# CCPS RFP#25-04 – NORTHEAST MIDDLE/HIGH SCHOOL REPLACEMENT PROJECT

#### **ADDENDUM #8**

September 18, 2024

Revise sheet A800 per attached reissued sheet:

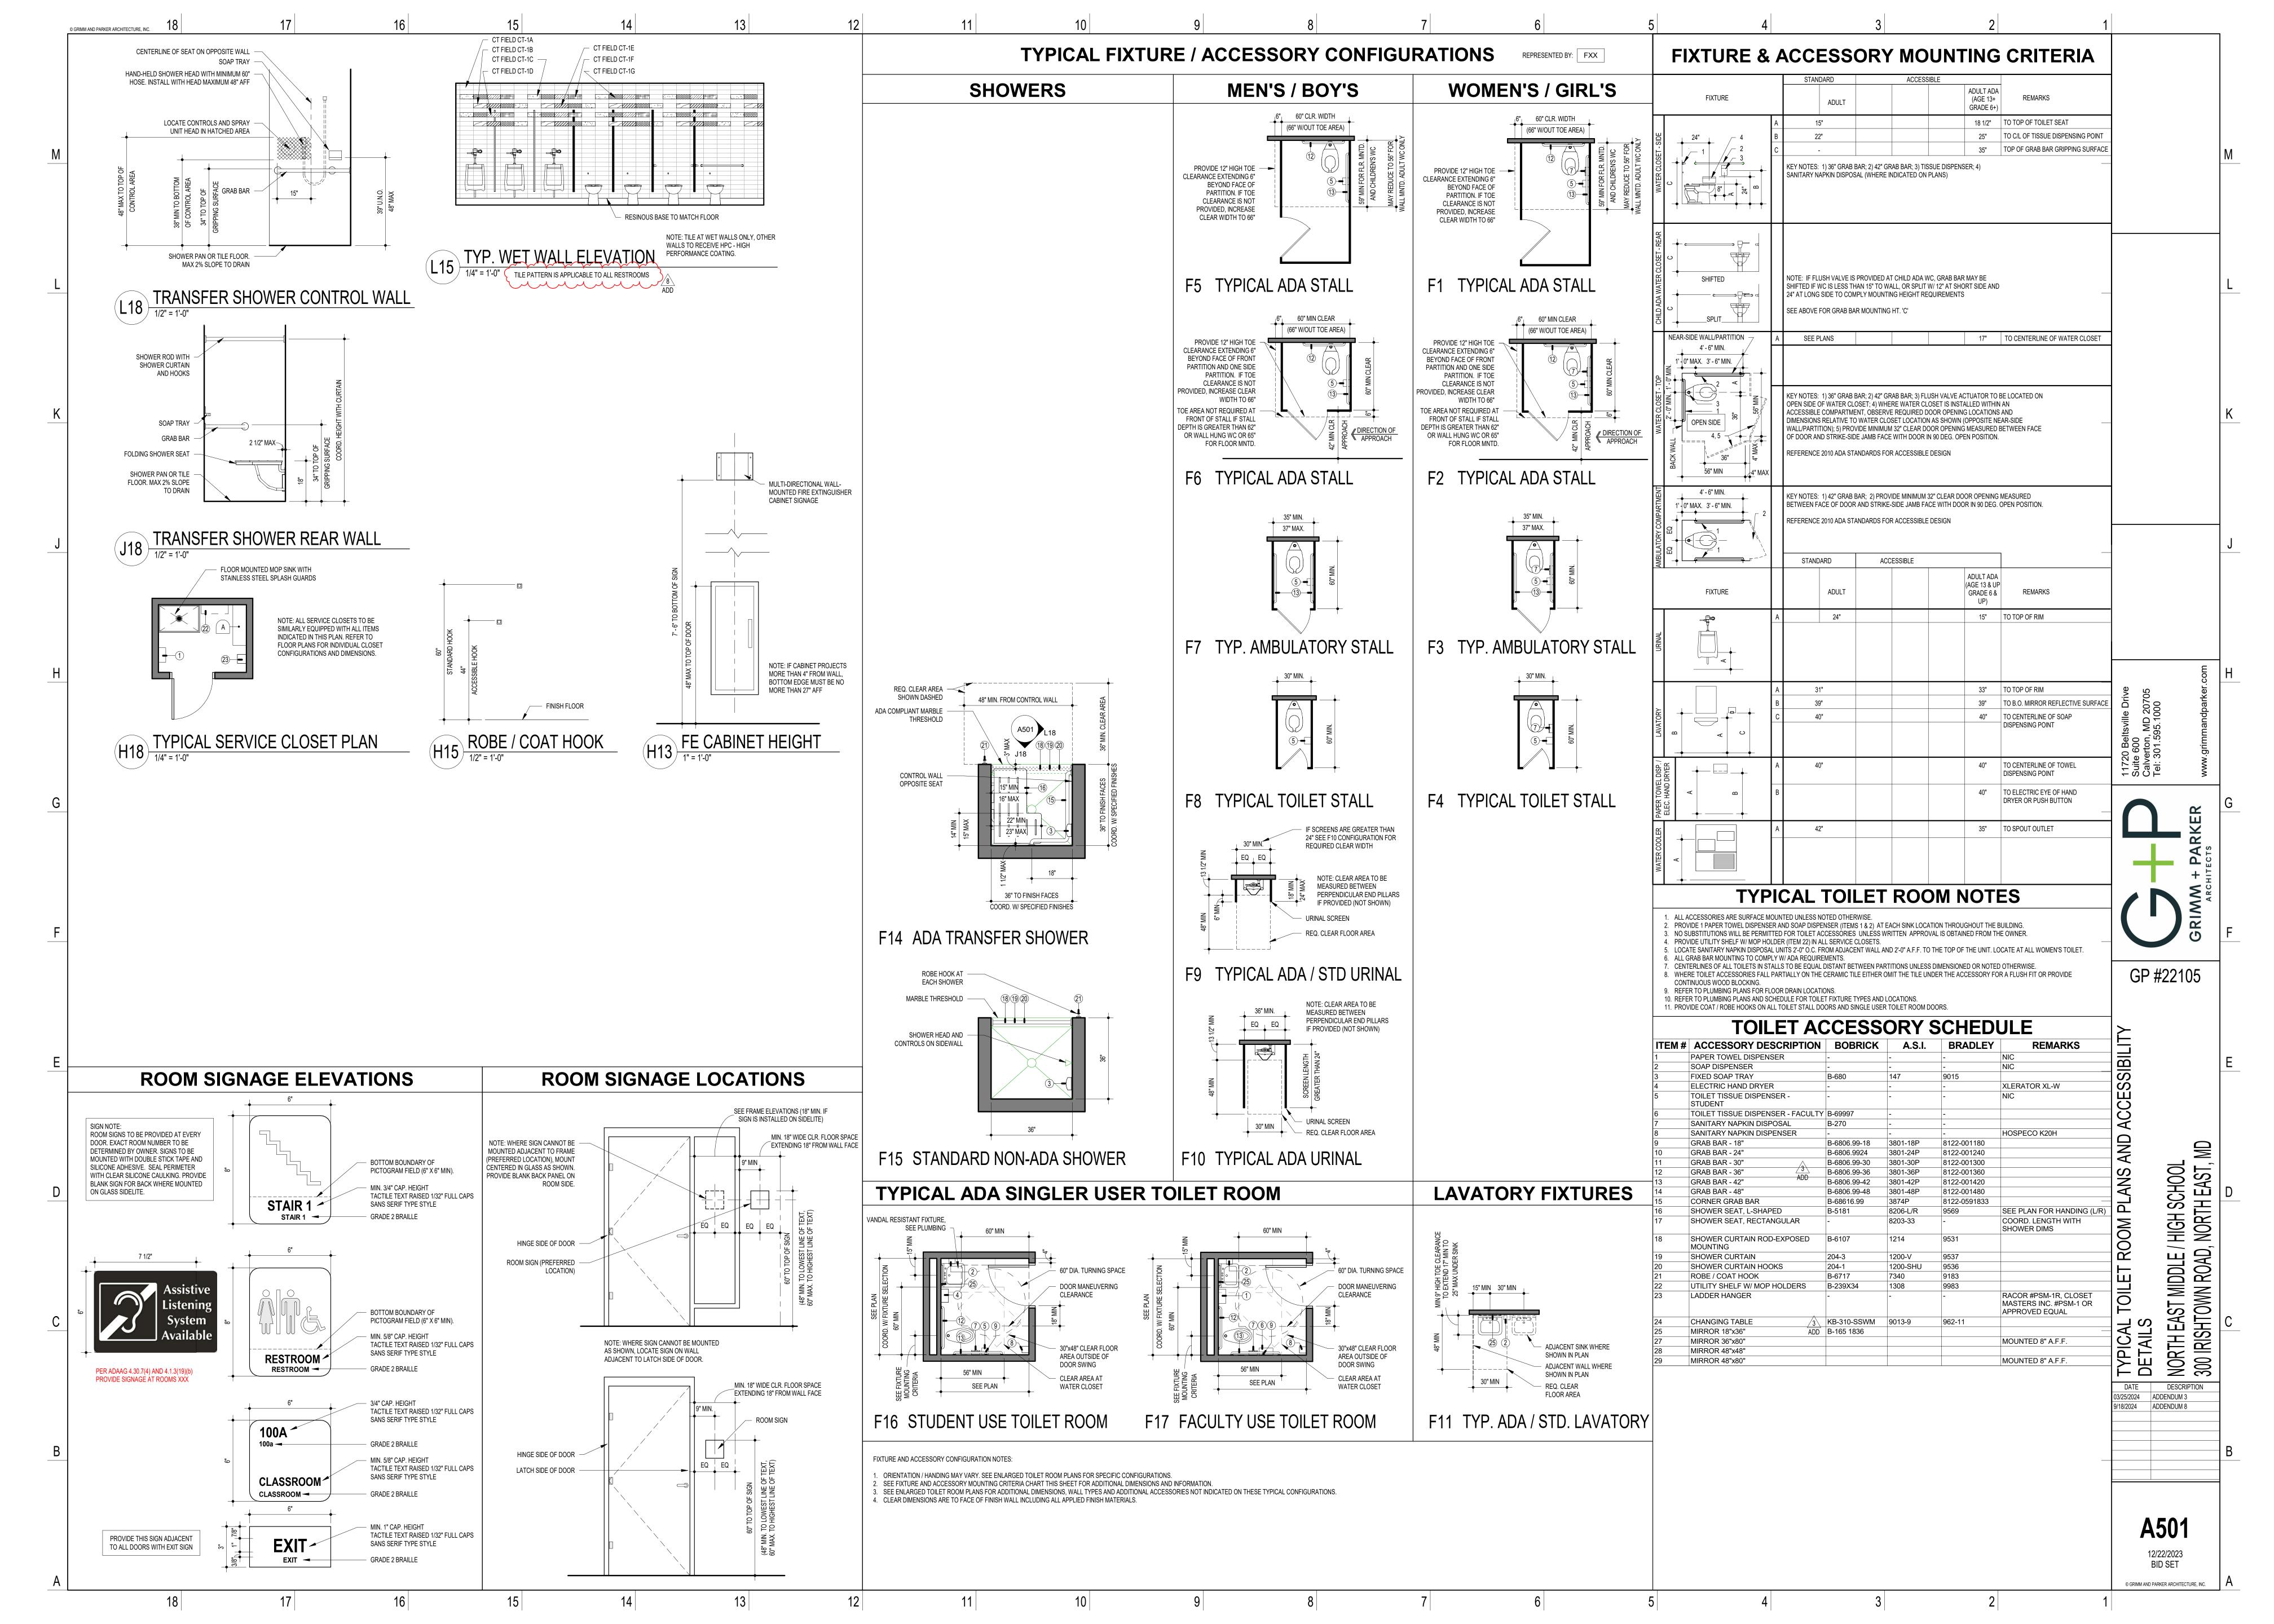
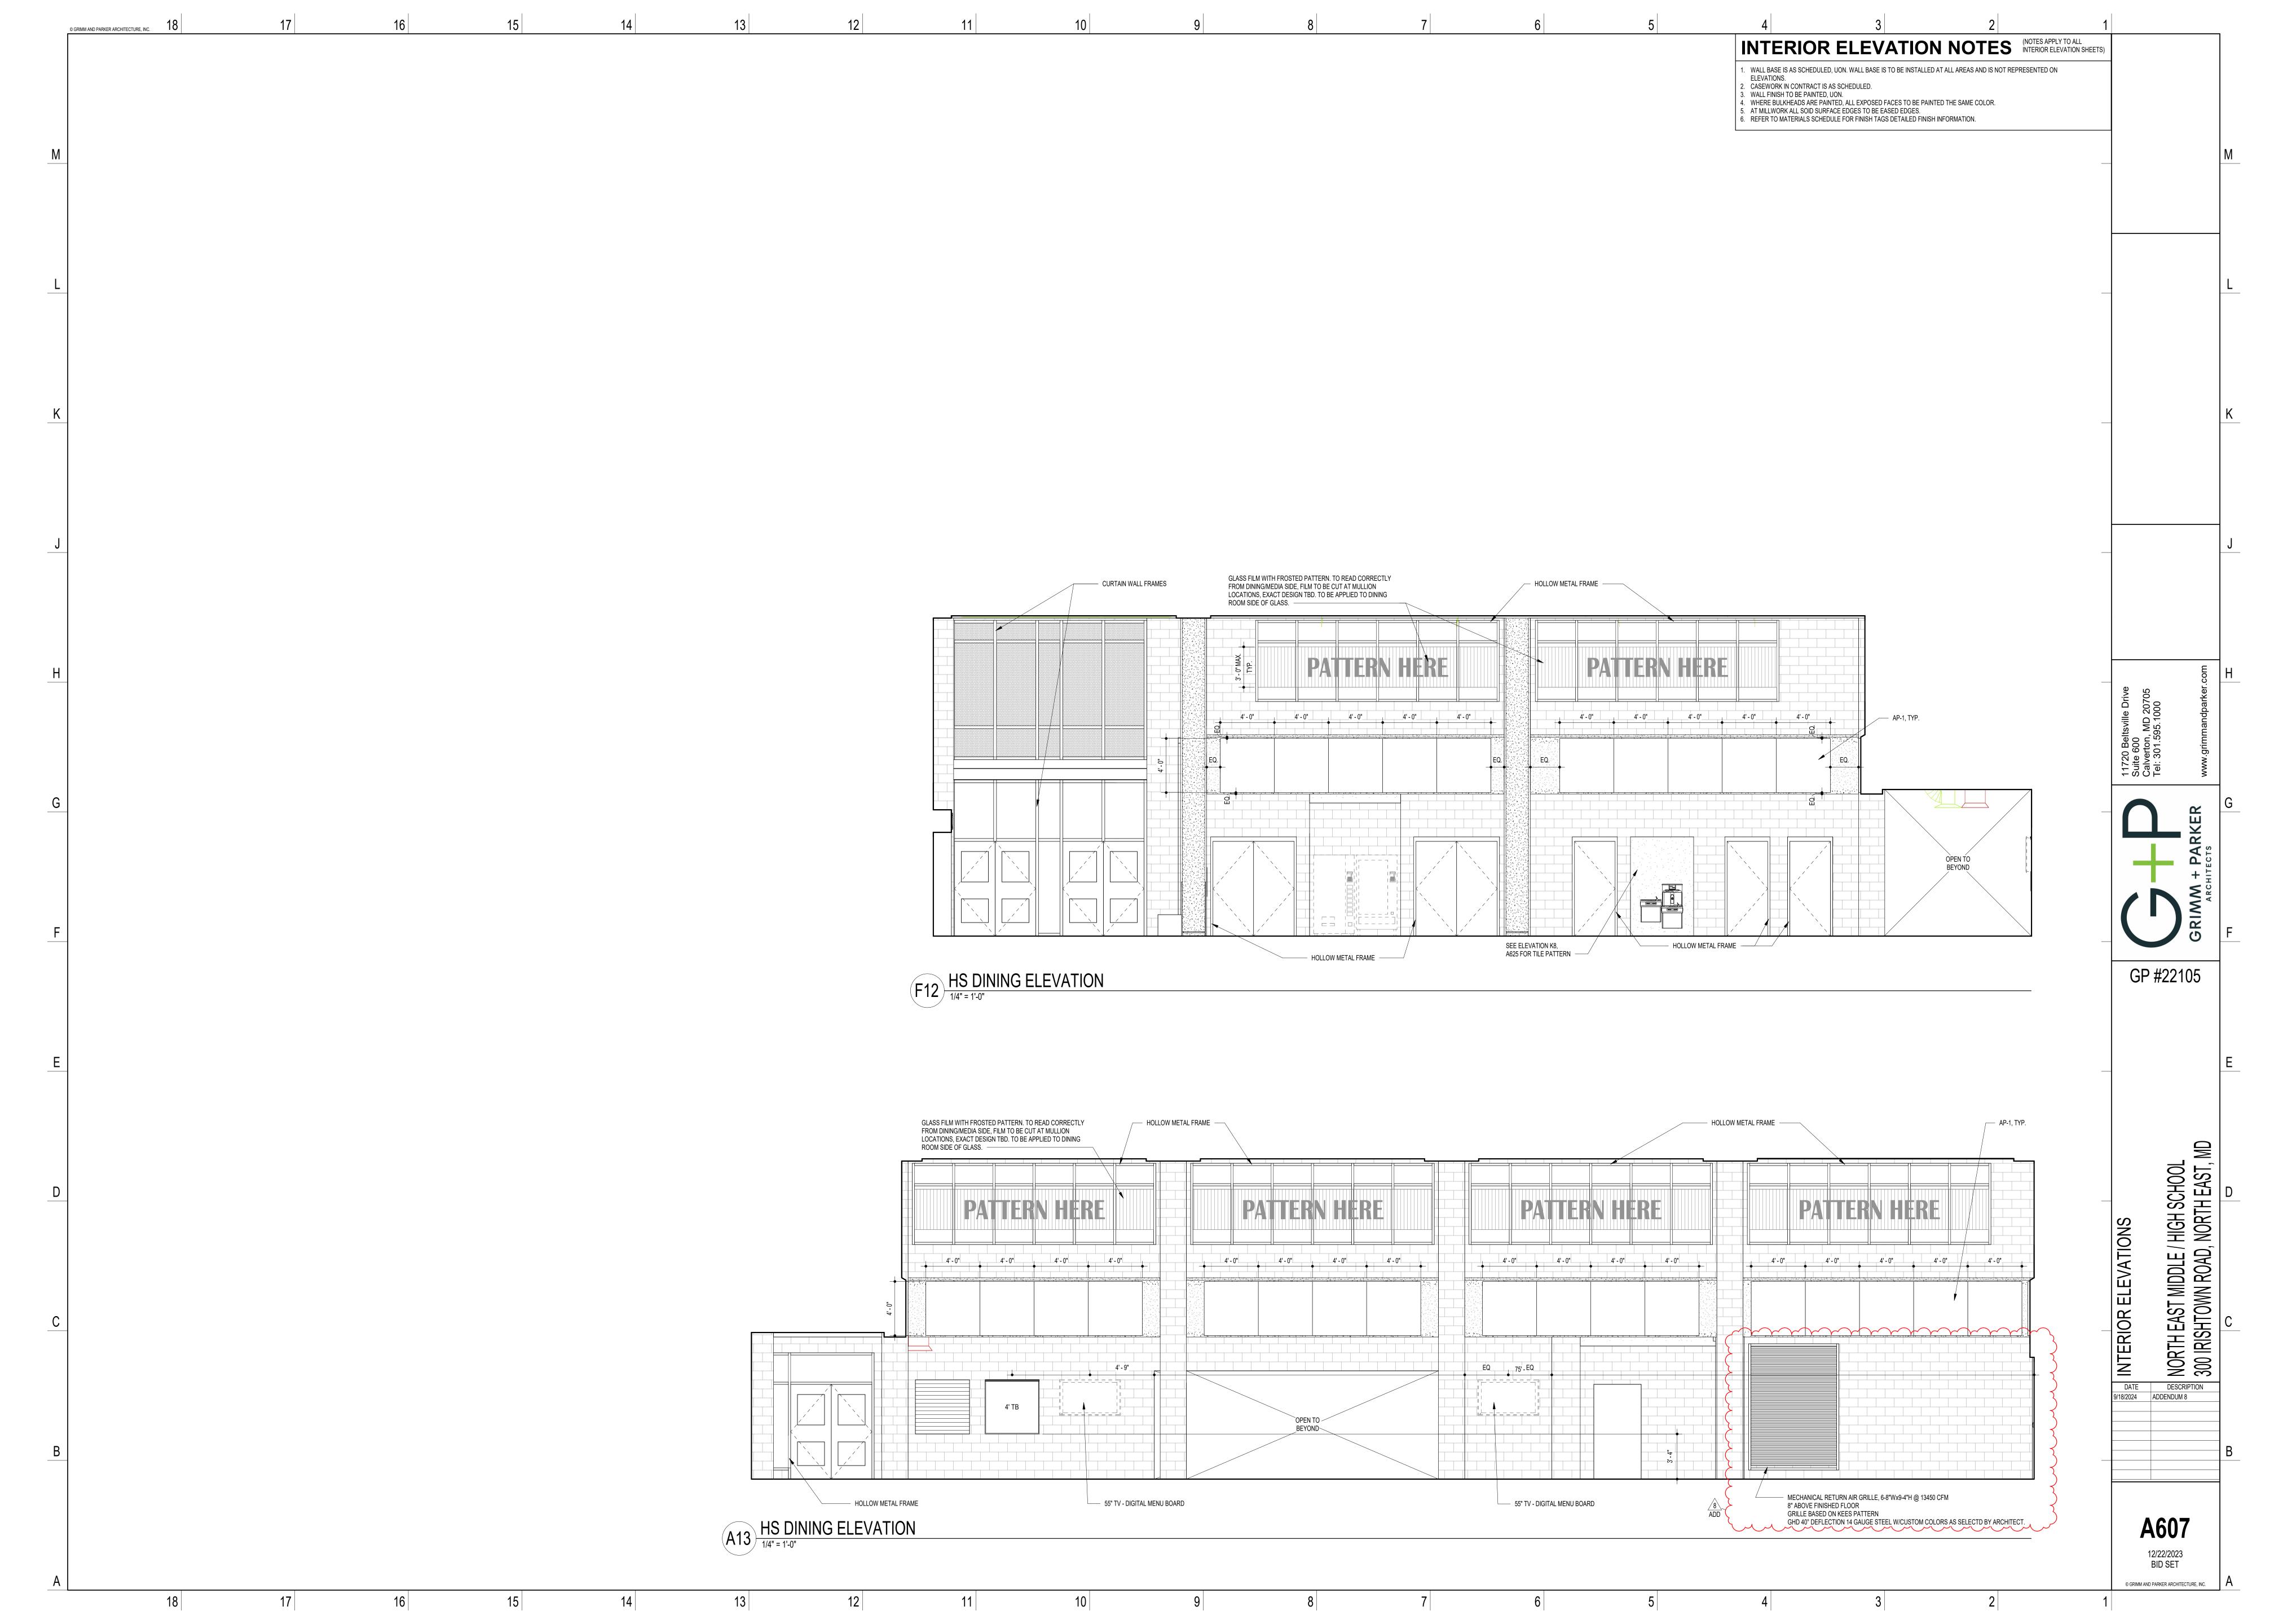
**REVISE** Revise E8 Ice Machine manufacturer and product # to SCOTSMAN UC2024MA-1
